*Markham MTS#3
Install New LV Shunt Capacitor
CAA ID 2003-EX132*

Connection Applicant: Markham Hydro

Final Report

July 31, 2003

Figure 1. Markham MTS#3 Single Line Diagram

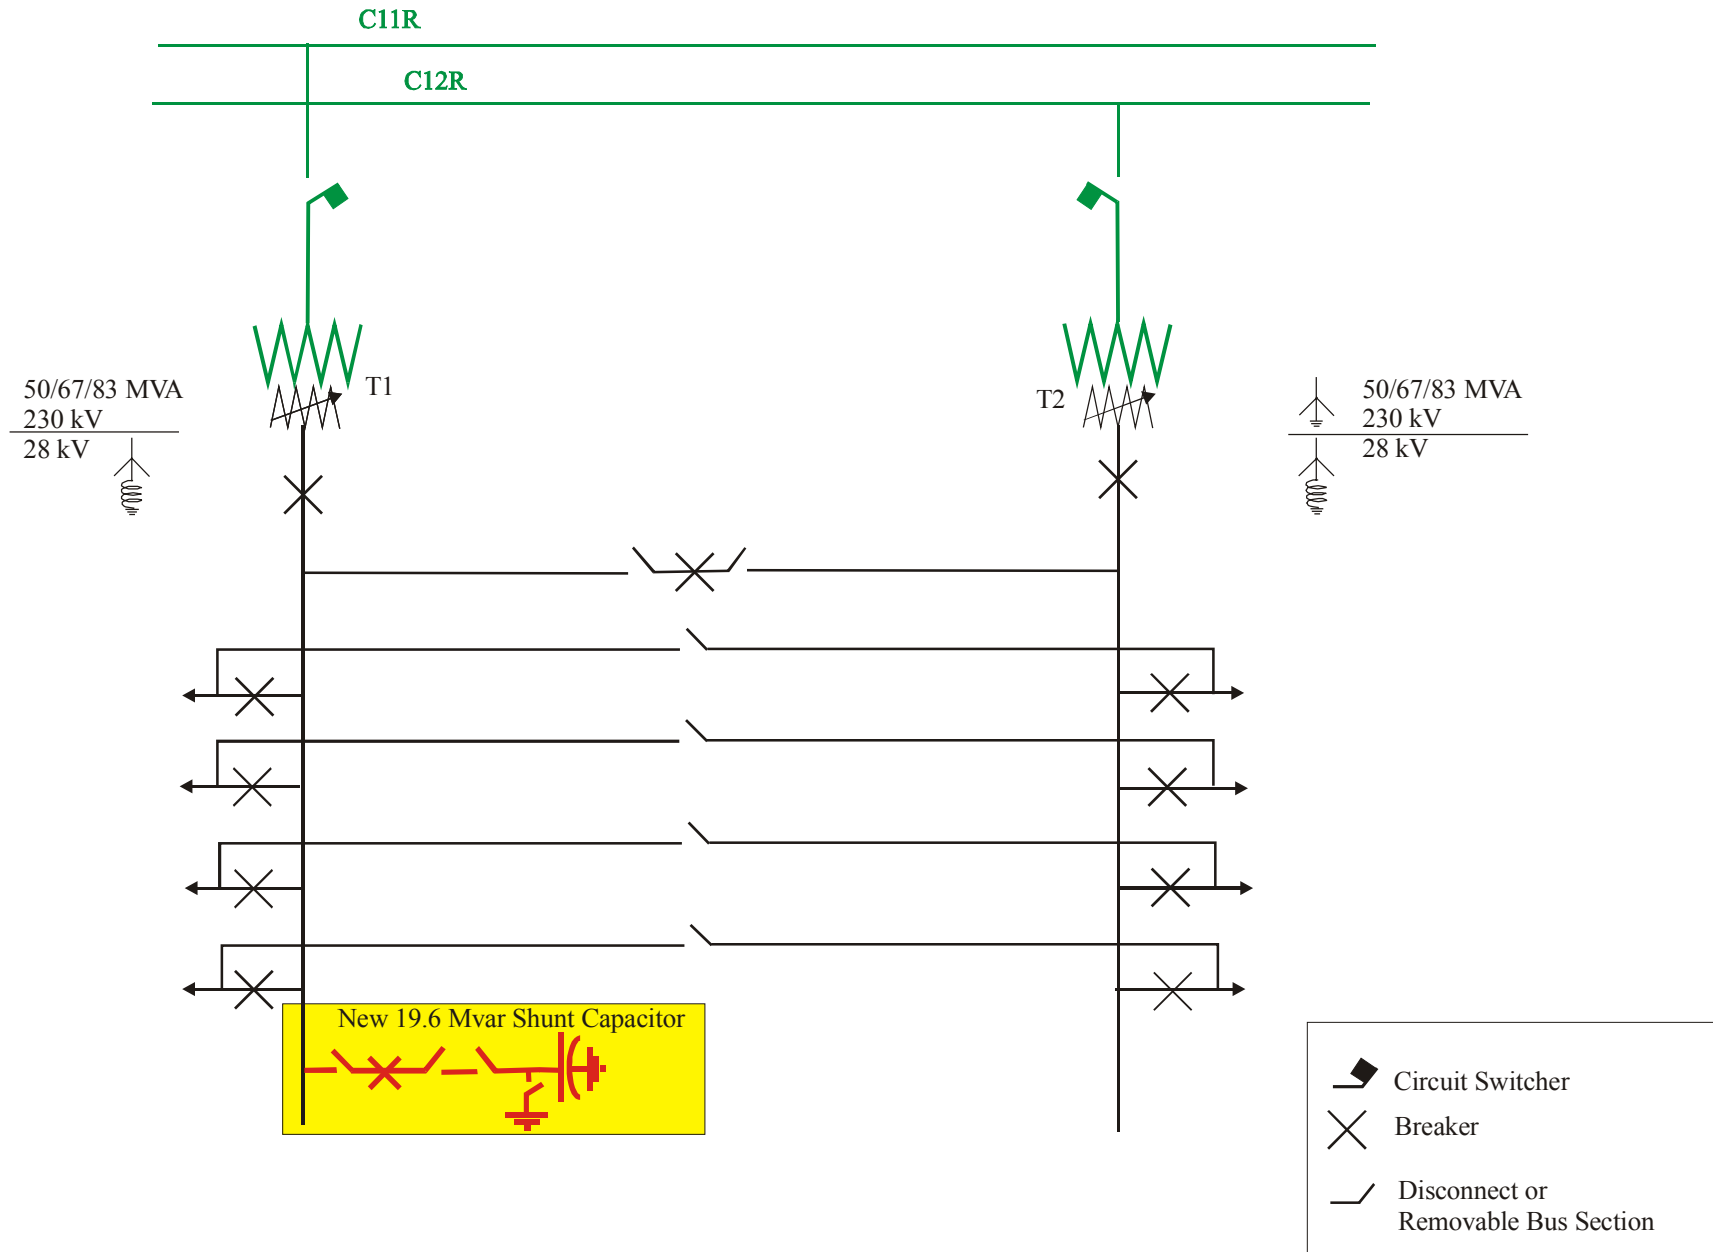
The new shunt capacitor will be connected directly to the 27.6 kV E bus at Markham MTS#3 via two series connected disconnect switches, one vacuum circuit breaker and a third disconnect switch, as shown in Figure 1. A grounding switch will be installed between the shunt capacitor and the first disconnect switch.

This assessment concluded that the addition of the LV shunt capacitor at Markham MTS#3 has no adverse effect on the reliability of the IMO-controlled grid and provides improvement to the load power factor and station voltage.

Markham Hydro is required to provide on-line monitoring facilities for the shunt capacitor isolating breaker status.

It is thus recommended that notification of approval be granted for the installation of an LV shunt capacitor bank at Markham MTS#3.
